# STAFF RECOMMENDATION

NCPC File No. MP57

**U.S. NATIONAL ARBORETUM**  
**MASTER PLAN MODIFICATION AND CHINESE GARDEN**  
3501 New York Avenue, NE  
Washington, D.C.

January 25, 2007

**SITE DEVELOPMENT CONCEPT FOR CHINESE GARDEN**

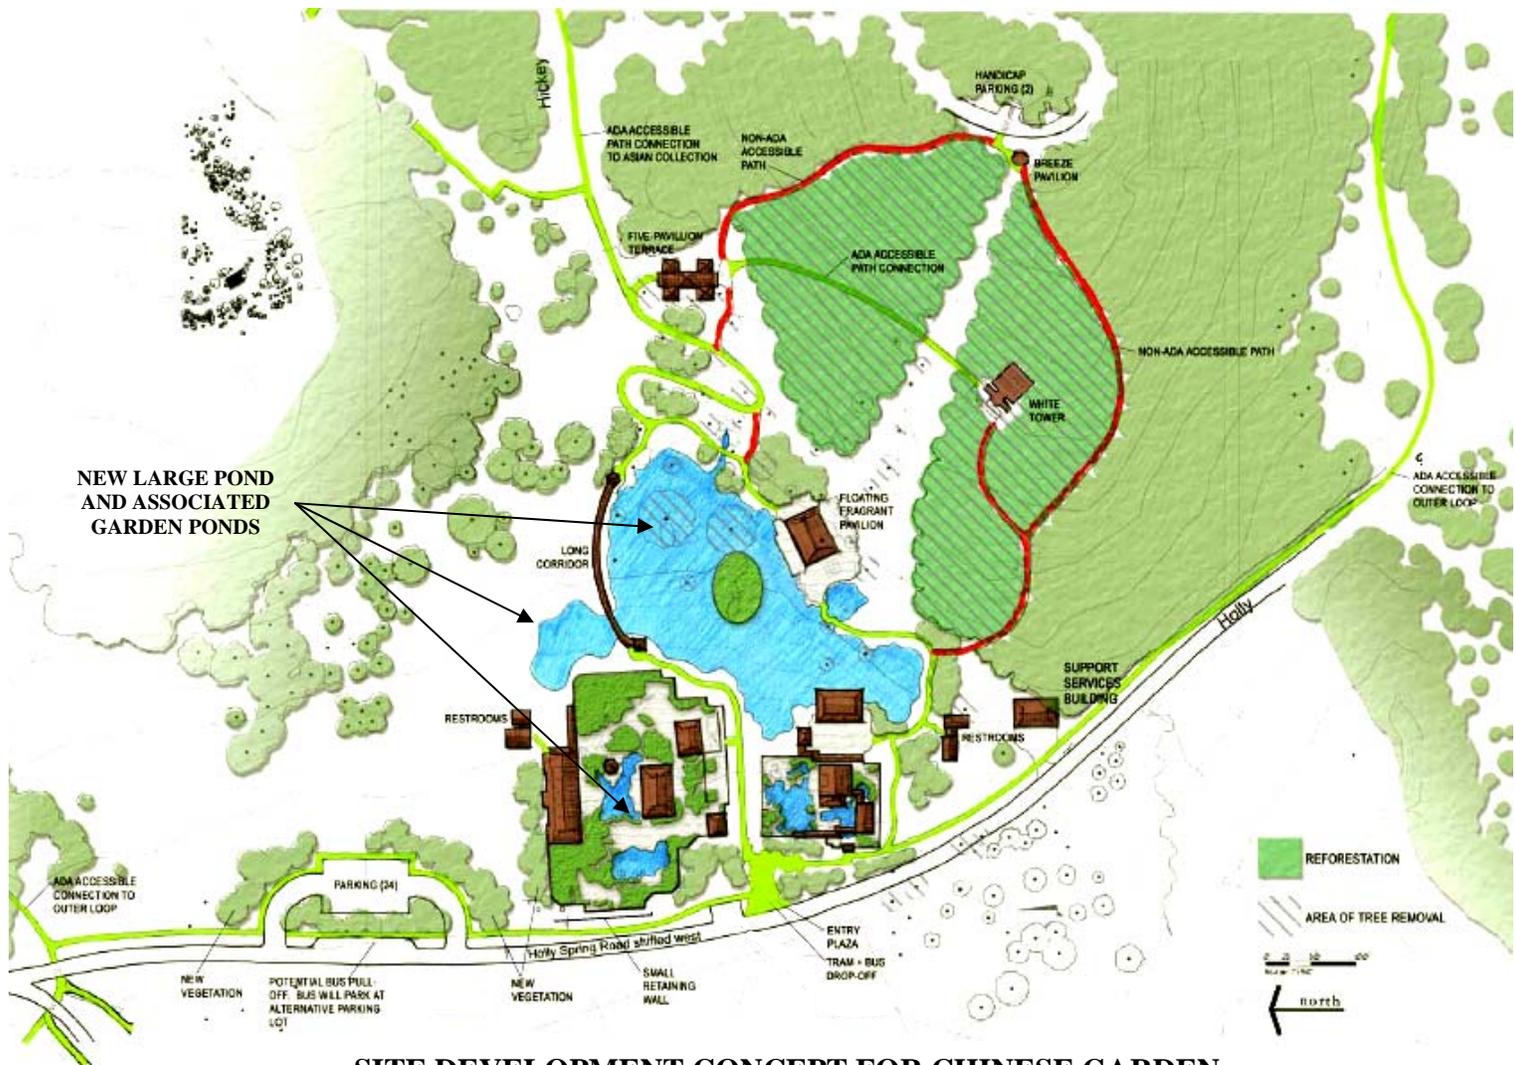
- **Notes** that the Chinese Garden perimeter must demonstrate, in its progress design, full incorporation of additional new planting of tree species.
- **Emphasizes** that further design review of the character development for the boundary of the Garden adjacent to Holly Spring Road should be undertaken by the Arboretum to reduce the full impact of the 20-plus new structures that would be placed into the setting of this area.

Staff believes the increased density and the nature of the site development concept for the Chinese Garden is clear, but needs to be carefully transitioned to the existing landscapes present at the Arboretum. The desired change in character and basic attributes of the planned Chinese Garden are important campus open space modifications and involve various size buildings adjacent to very naturalistic settings. The impact of development on the eastern tree canopy involving the existing white pines is regrettable; but more persuasive is the staff concern regarding building massing and buffer space adjacent to the Garden. Staff recommends that the Commission emphasize that the Garden perimeter must demonstrate, in its progress design, full incorporation of new planting of tree species. Additionally, further design review of the character development for the boundary of the Garden, adjacent to Holly Spring Road, should be undertaken by the Arboretum to reduce the full impact of the 20-plus new structures that would be placed into the foreground setting of this area. As it stands, the garden development crowds this foreground near the re-aligned road, in contrast to the revered tradition of garden development that is fitted to the land as scenic sections to be disclosed—not at one glance, but gradually in sequences.

**ANACOSTIA WATERFRONT ACCESS DRIVE CONCEPT  
SITE DEVELOPMENT PLAN**

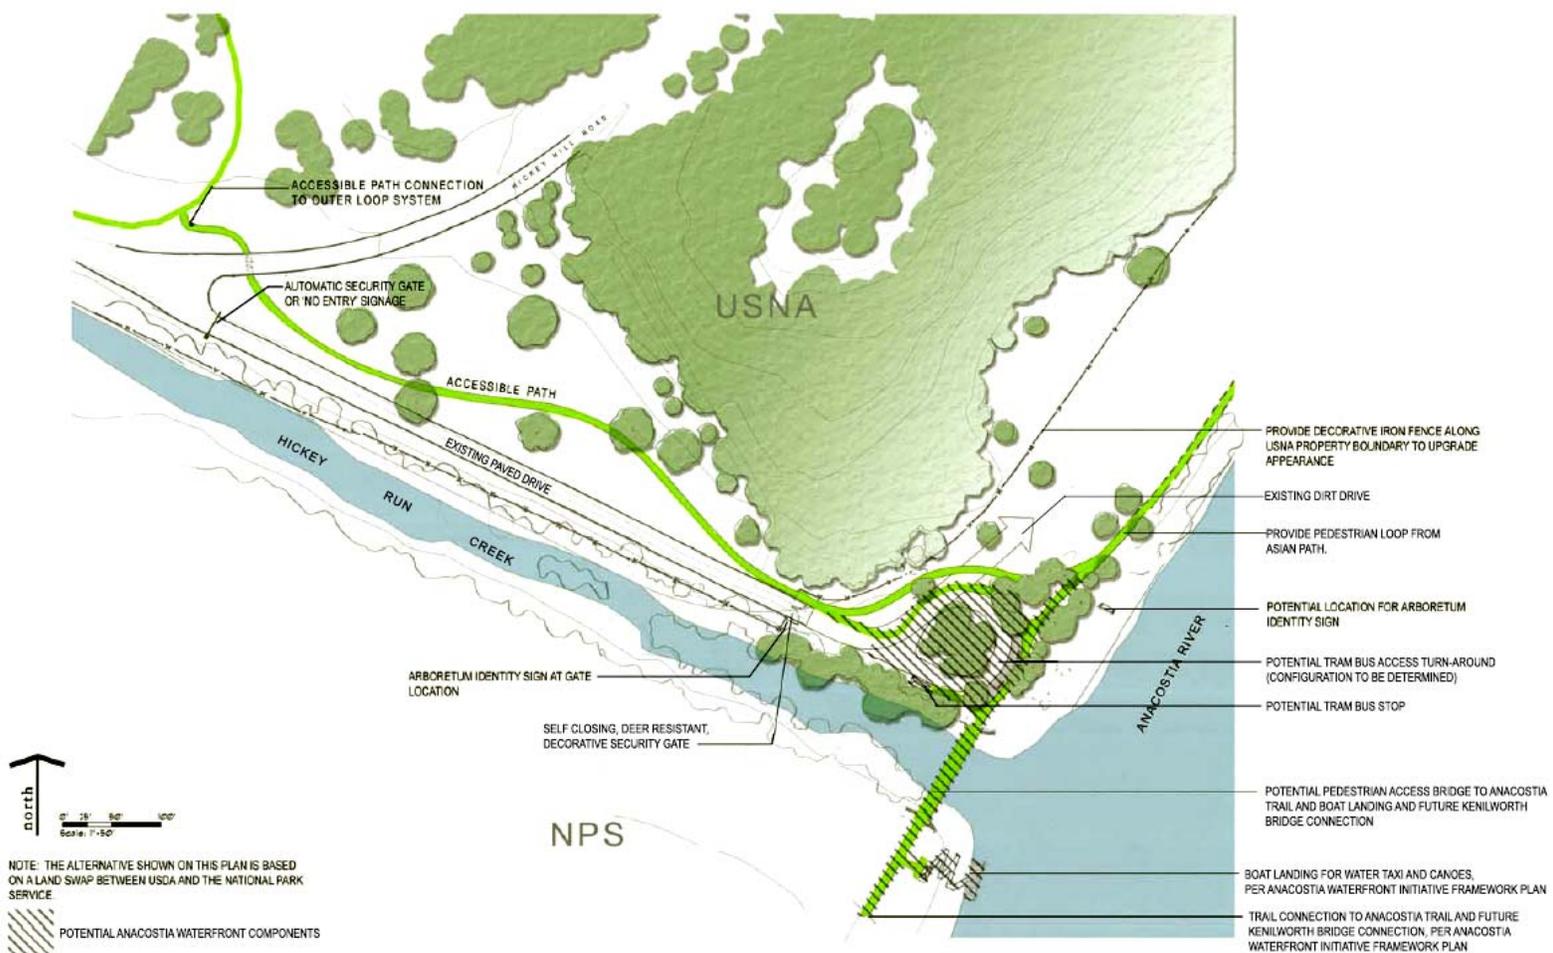
- **Strongly encourages** the Arboretum to coordinate the planned riverside trail with the National Park Service to ensure the revised property boundary is appropriately defined and that no inadvertent encroachment on Park Service property occurs by way of the path development to the Asian Collection entrance near the Anacostia River.
